SERVICE DIRECTIVE BULLETIN NO. T-041

1. SUBJECT: Mounting Hardware Inspection

2. MODEL: TH-28, 480, 480B

3. EFFECTIVITY: S/N 5147 and prior

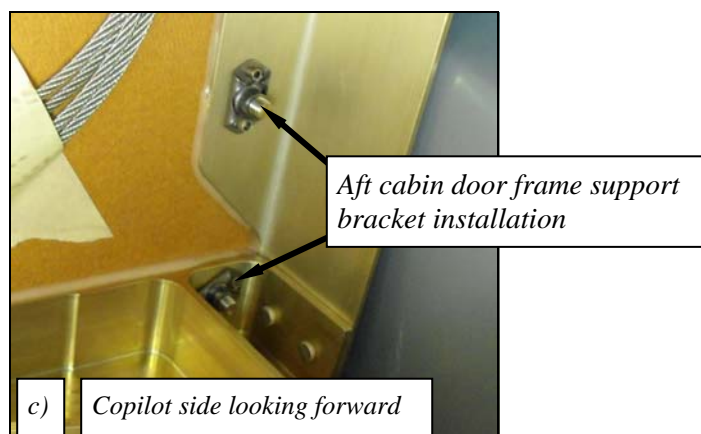
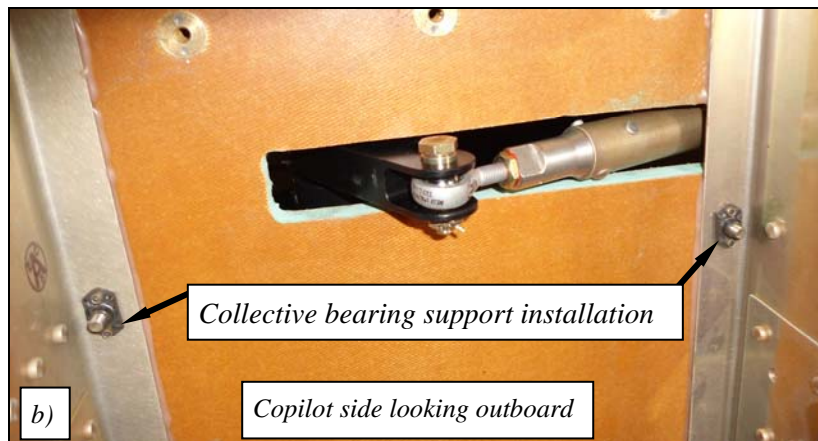
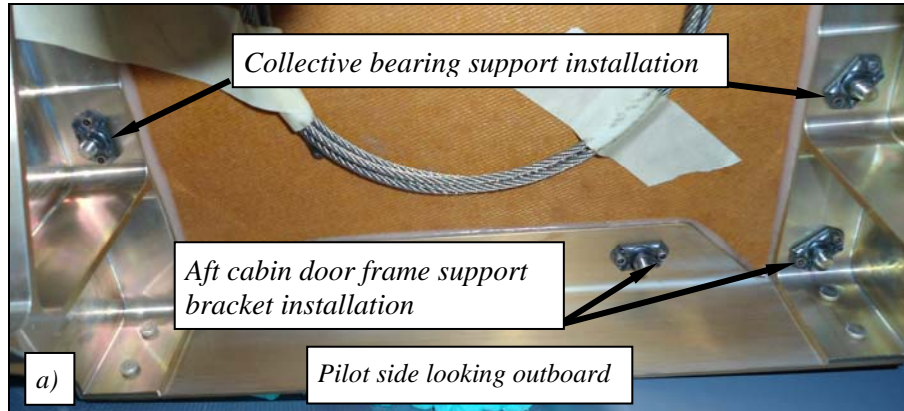
6.2 Locate the installation bolts or screws and nutplates under the cabin floor for the following installations:

6.2.1 Collective torque tube bearing supports (*Figure 1a and 1b*)

6.2.2 Aft cabin door frame support brackets (*Figure 1a and 1c*)

Figure 2. Thread engagement: *a)* inadequate thread engagement and *b)* adequate thread engagement.

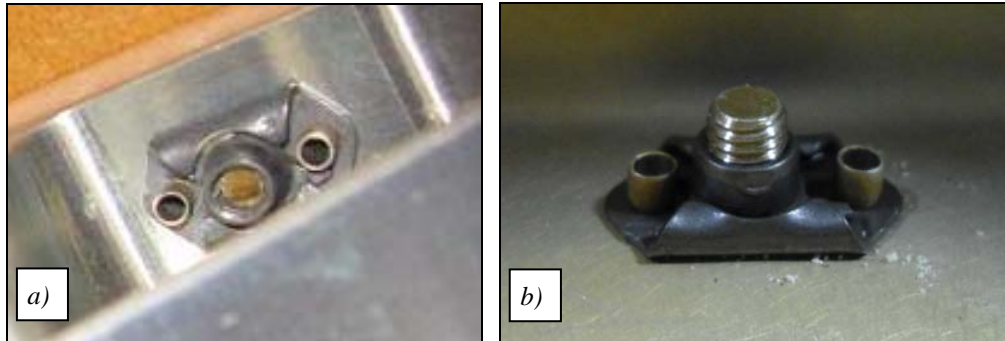
- 6.3 Inspect all bolt or screw attachments for complete thread engagement. At least one thread should be exposed beyond the nut. *Figure 2a* shows an example of inadequate thread engagement. *Figure 2b* shows an example of adequate thread length.

- 6.4 If thread engagement is adequate, no additional inspection is required. Re-install the access panels.
- 6.5 If thread engagement is not acceptable, proceed to paragraph 6.6 to replace the bolt(s) or screw(s).
- 6.6 Collective bearing supports
- 6.6.1 Replace the applicable bolt(s) in accordance with *Figure 4*.
- 6.7 Cabin support brackets
- 6.7.1 Aft cabin support brackets: Use P/N MS27039-1-16 for the location with the sheet metal bracket. Use P/N MS27039-1-17 for the location with the machined fitting. See *Figure 3*.
